# UNITED STATES DEPARTMENT OF THE INTERIOR BUREAU OF LAND MANAGEMENT

6. If Indian, Allottee or Tribe Name		
SUBMIT IN TRIPLICATE - Other instructions on page 2					7. If Unit or CA/Agreement, Name and/or No.		
1. Type of Well					8. Well Name and No. GOLDEN SPUR		
⊠ Oil Well					9. API Well No.		
CONOCOPHILLIPS COMPANY E-Mail: ashley.bergen@conocoph					30-015-41230-00-S1		
3a. Address MIDLAND, TX 79710 1810  3b. Phone Ph: 432-			(include area code) 8-6938		10. Field and Pool or Exploratory Area WC 015 G 05 S263125N

#### **GOLDEN SPUR FEDERAL FBS 25 3H**

## Approved for a period of 1 year ending 12/14/2017 subject to conditions of approval.

The current and proposed wellbore diagrams are attached.

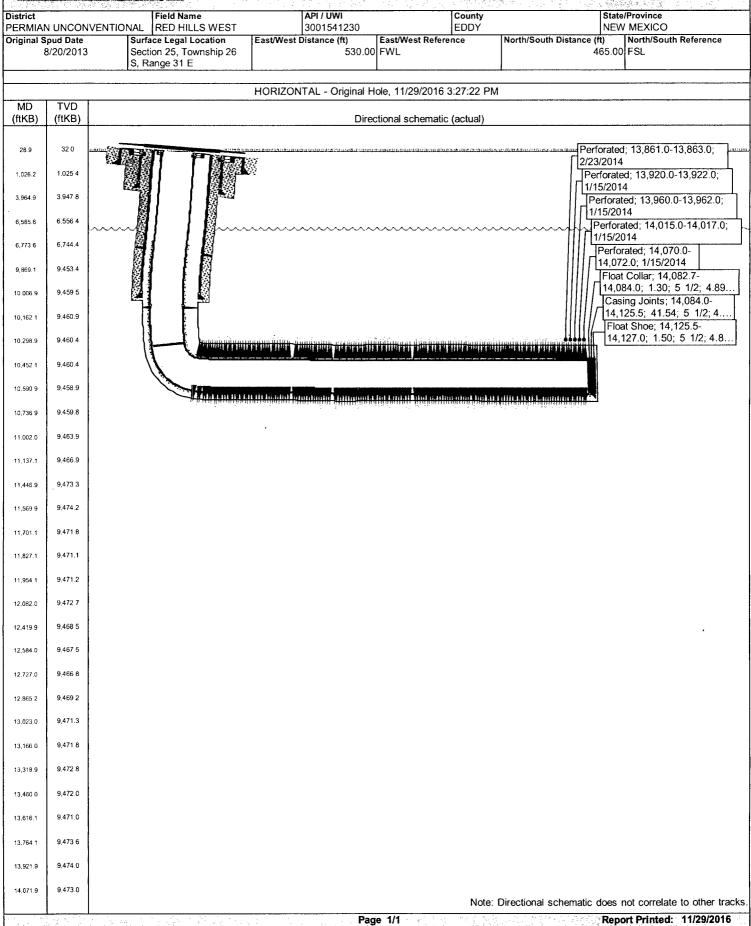
#### Golden Spur 25 FBS 3H

- 1. Well is approved to be TA/SI for a period of 1 year or until 12/14/2017
- 2. Must submit NOI to recomplete or NOI to P&A. Must be submitted by 12/14/2017
- 3. COA's met at this time.
